CONSOLIDATED EDISON COMPANY OF NEW YORK, INC.

Indian Point Station, Unit No. 2

Applicant's Responses to Round Two Questions
Submitted by the Citizens' Committee for the
Protection of the Environment (Set H)
on March 9, 1971

March 29, 1971

Figure 1, attached, gives the temperature distributions through the vessel wall obtained by that analysis as a function of time after initiation of cooling.

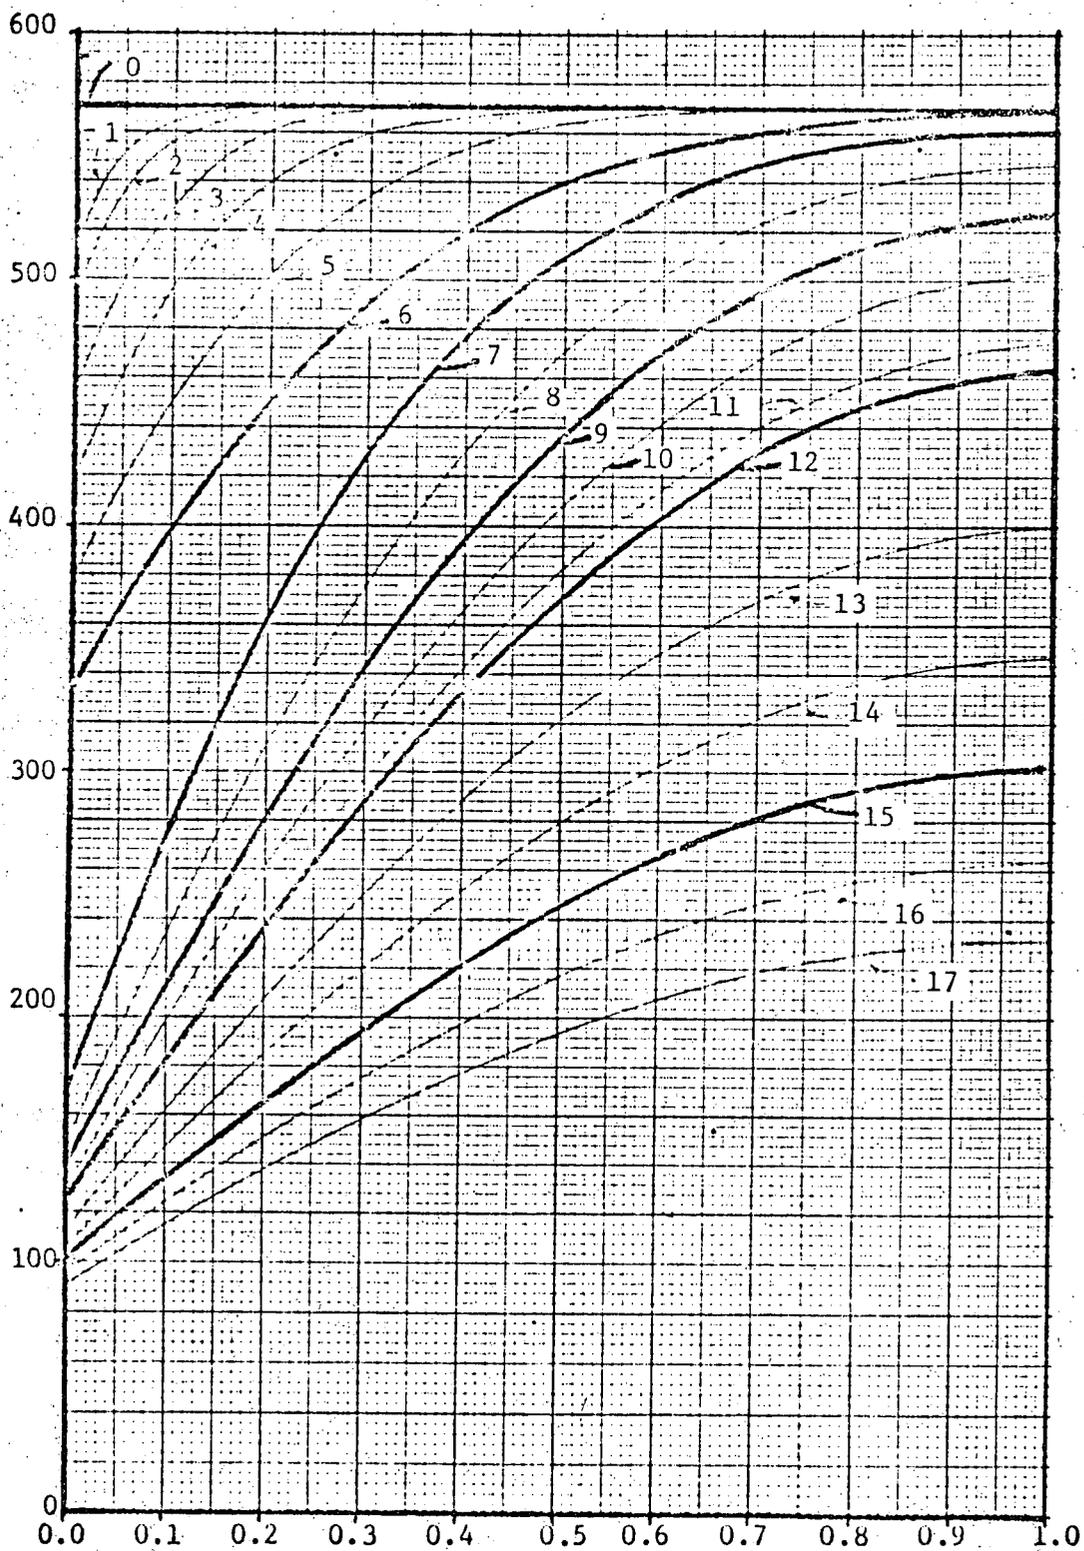
Question: Explain in detail the manner in which the following factors taken together and separately can affect the growth of flaws (indications, defects) in the reactor vessel including its welds and the primary piping system (if there is no effect, justify the conclusion; if there is, in your opinion, an insignificant effect, justify the conclusion regarding the extent of the effect and the insignificance of the effect).

- 5) all other relevant factors which will demonstrate the maximum possible stress at the weakest, possible point; and
- 6) answer the question with respect to the simultaneous impact of cooling water on the exterior of the reactor vessel as a result of the pipe break and the containment spray.

The analysis described in answer to Question D-50 is the appropriate analysis for the evaluation of the effects of cooling the reactor vessel with emergency core cooling water.
